Title SATA, FAN		
Size B	Document Number GENE-KBU6-MLD	Rev: A1.1_0_0
Date: <i>Tuesday, September 08, 2020</i>		Sheet: 23 of 42

Title LPT, HW Monitor		
Size Custom	Document Number GENE-KBU6-MLD	Rev: A1.1_0_0
Date: Tuesday, September 08, 2020		Sheet: 29 of 42

CPU FAN

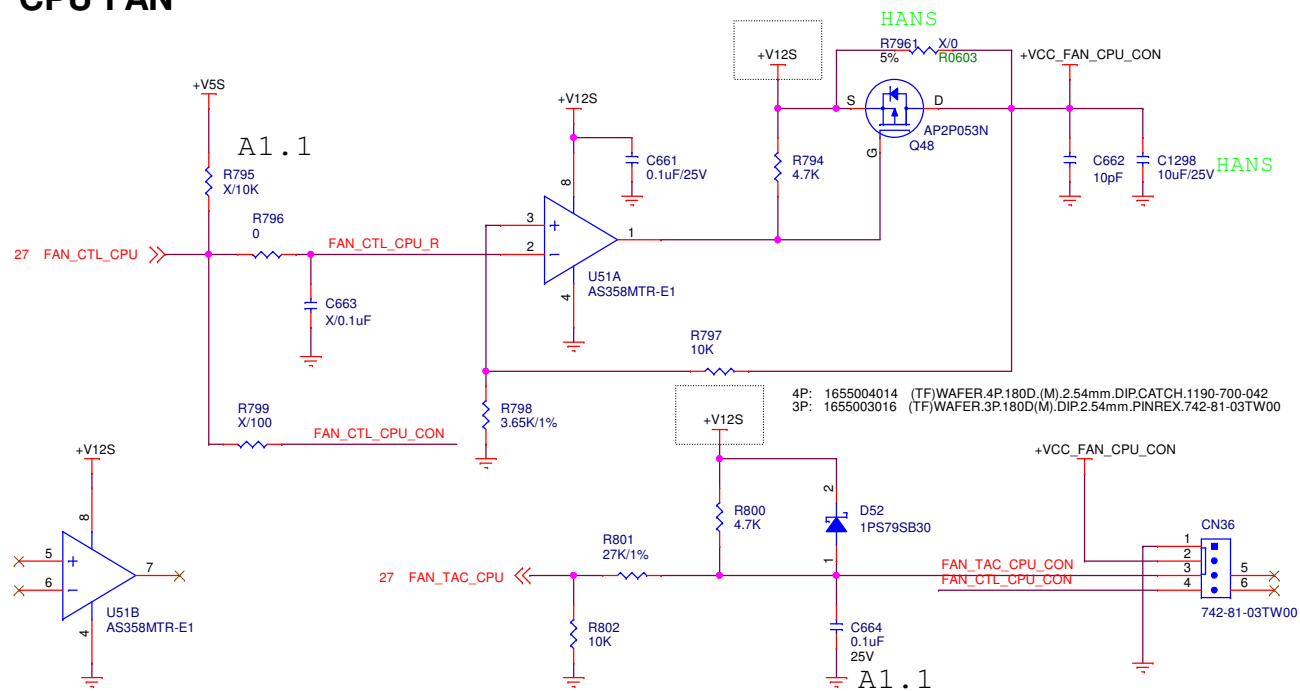
C664 耐壓需改 25 V
